Bardstown Road/Baxter Avenue Corridor Review
Overlay (BROD) District
21-OVERLAY-0037

1703 Bardstown Rd
(Zwanky V, formerly Slay Boutique)

Request

Elevations – 11/5/21

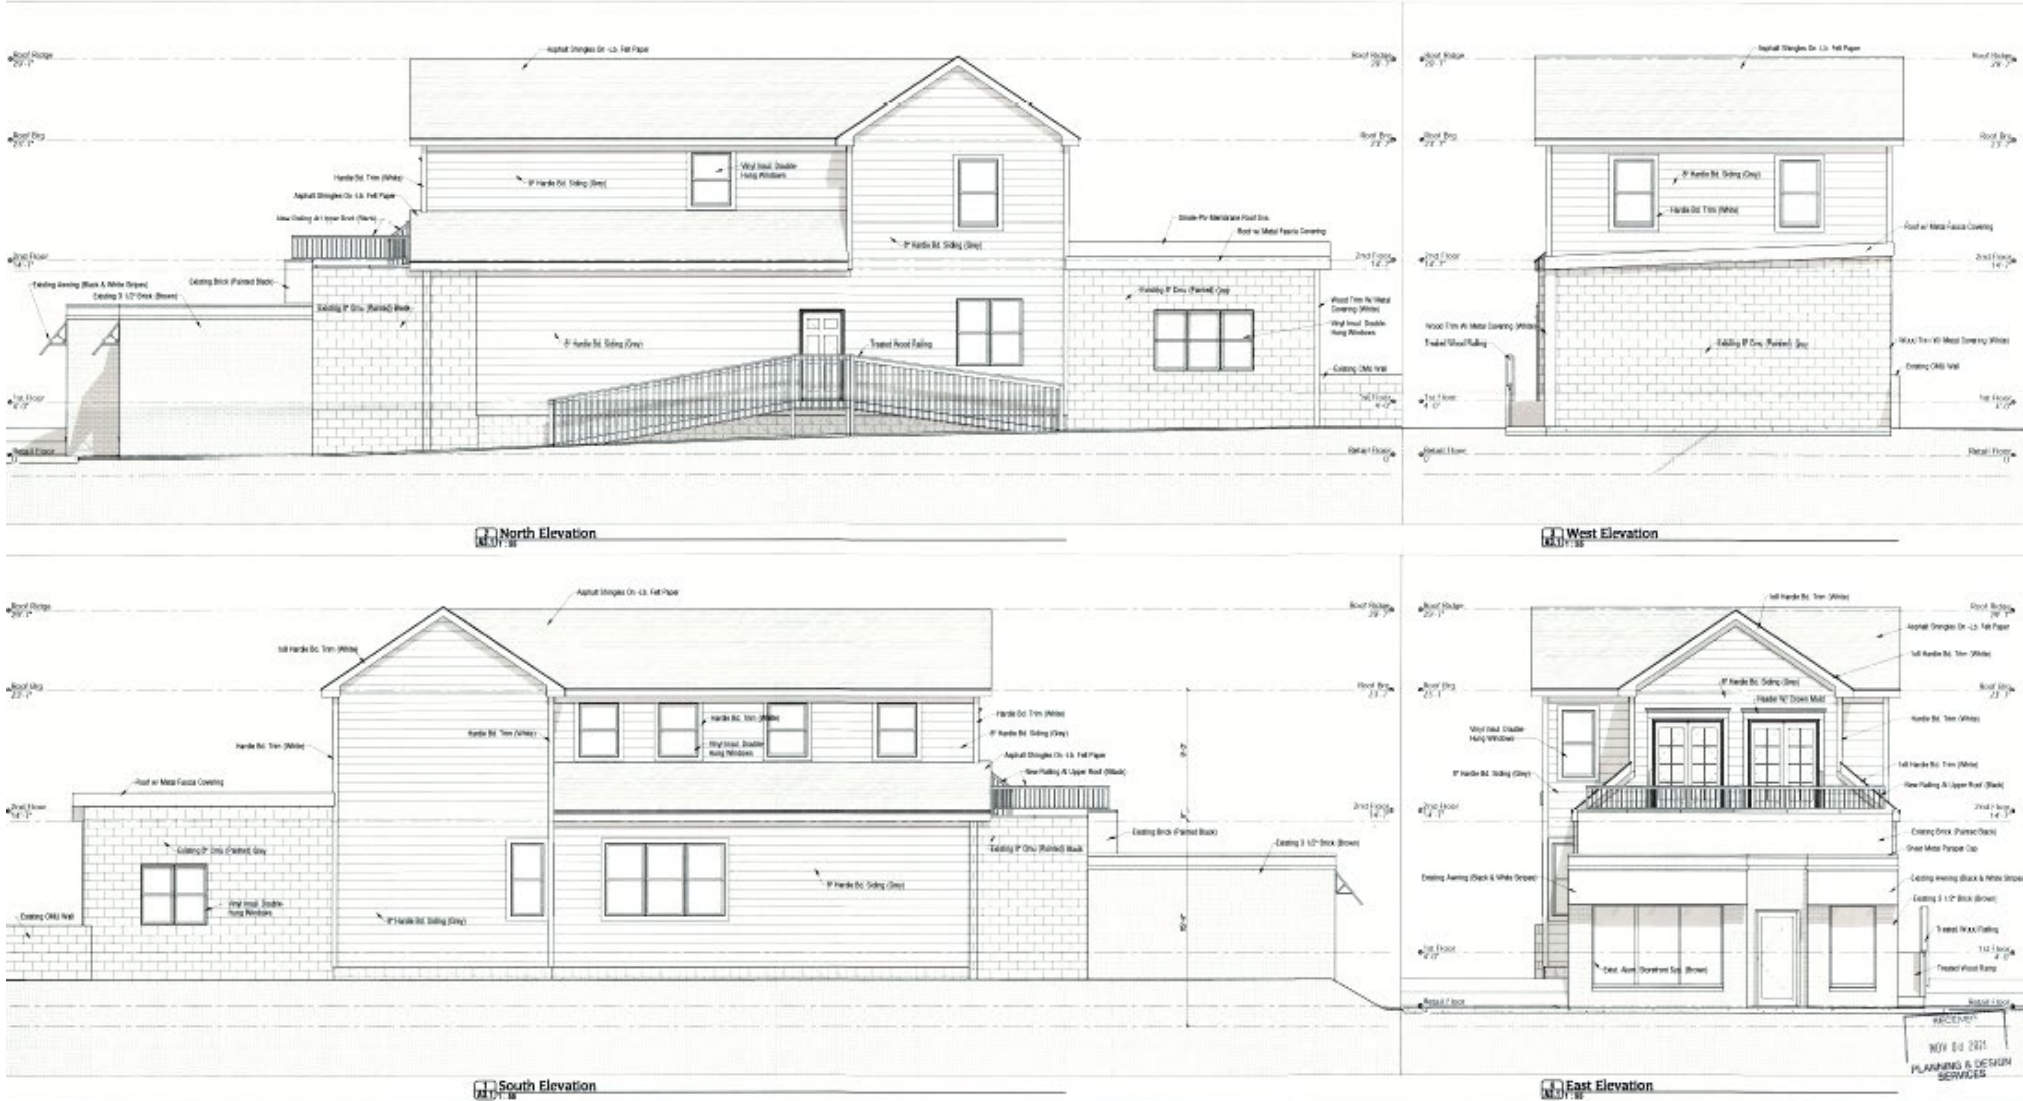
1. The final design of the openings (doors and/or windows) on the front façade off the dormer addition shall be approved by the Urban Design Administrator prior to installation.
2. The applicant shall install a roofing material on the dormer addition that is in kind to that used on other sloped roofs of the building.
3. Signage and public art not detailed in the application shall be reviewed separately and, if deemed necessary by the Urban Design Administrator, require an additional Overlay Permit.
